Compliance with EU Battery Regulations

MELSEC series, MELIPC series, and GOT2000 series

FA-A-0436-D

■ Q6BAT

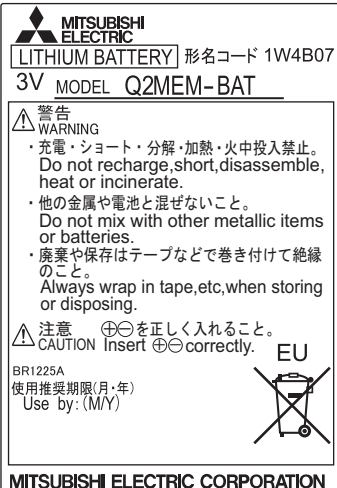
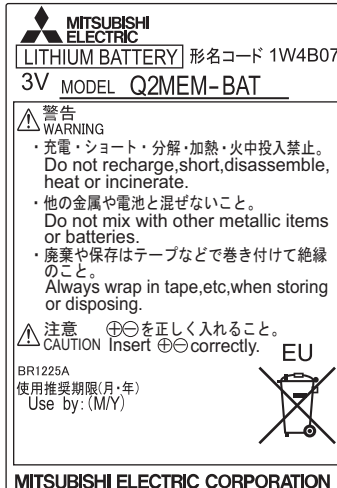
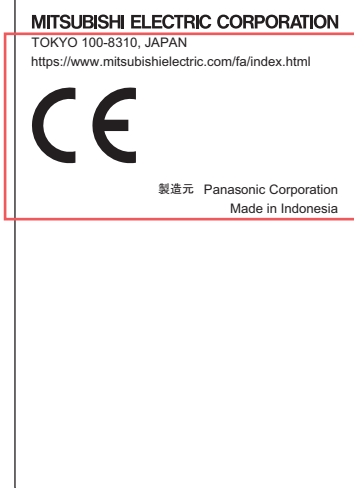
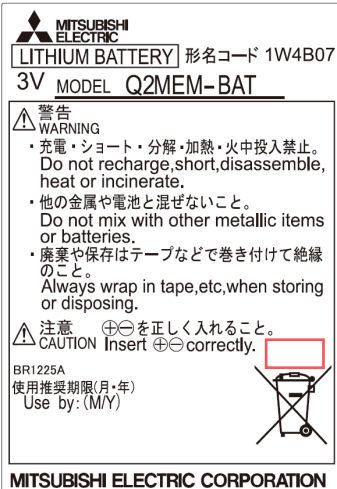
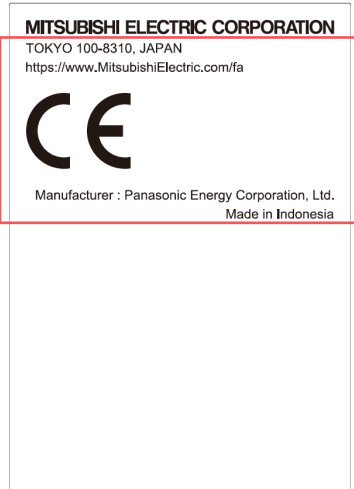
A sticker will be attached, or the label will be changed.

■ Q2MEM-BAT

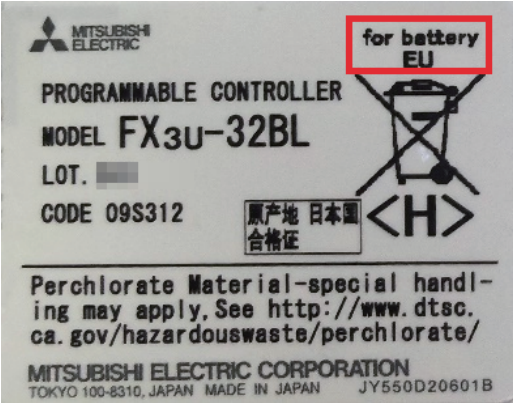
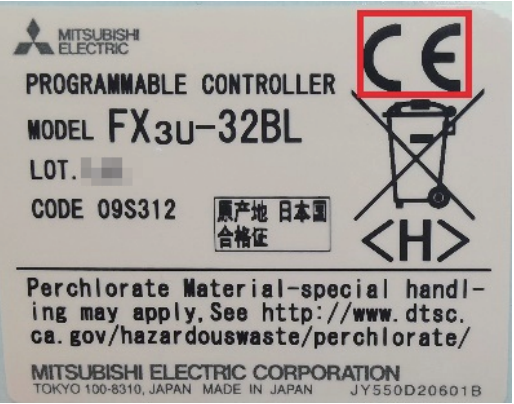
The CE mark, our head office address, and our website URL will be added on the rear of the packaging.
